V Bhagwan Birsa Biological Munda Biological Park, Ranchi

Setting up of an Animal Rescue Centre at Barwe, Ranchi

Proposed Aviary for Drongo, Woodpeckers, Parrot, Barbets, Bee-eaters, Doves, Green pigeons.

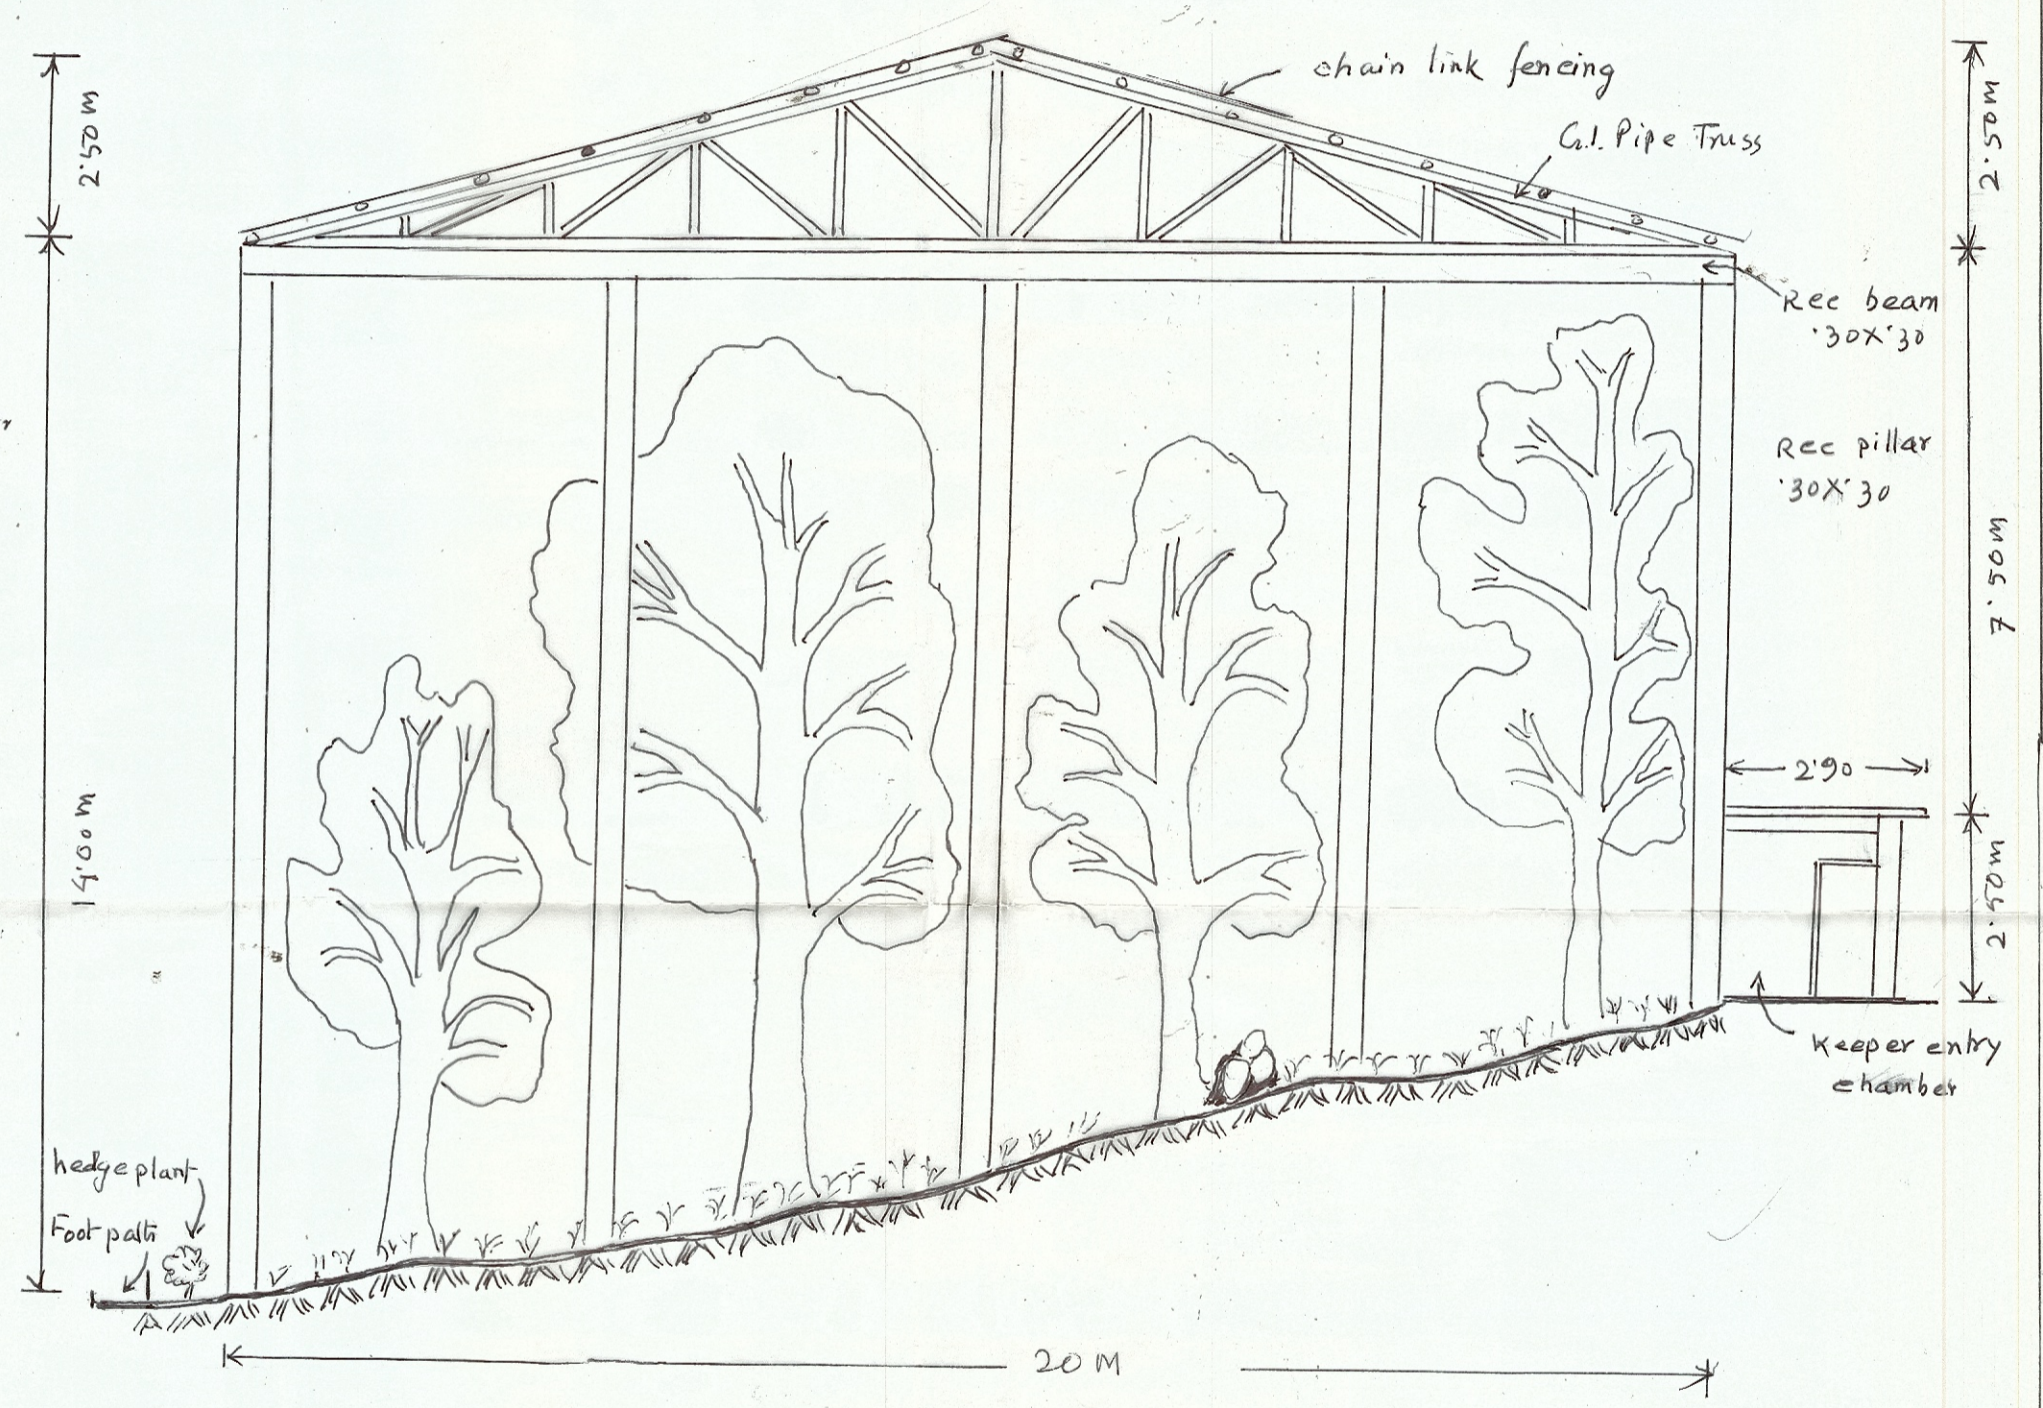
The design was scrutinized by the Members and approved subject to that the height of the aviary should be reduced to 30 feet.
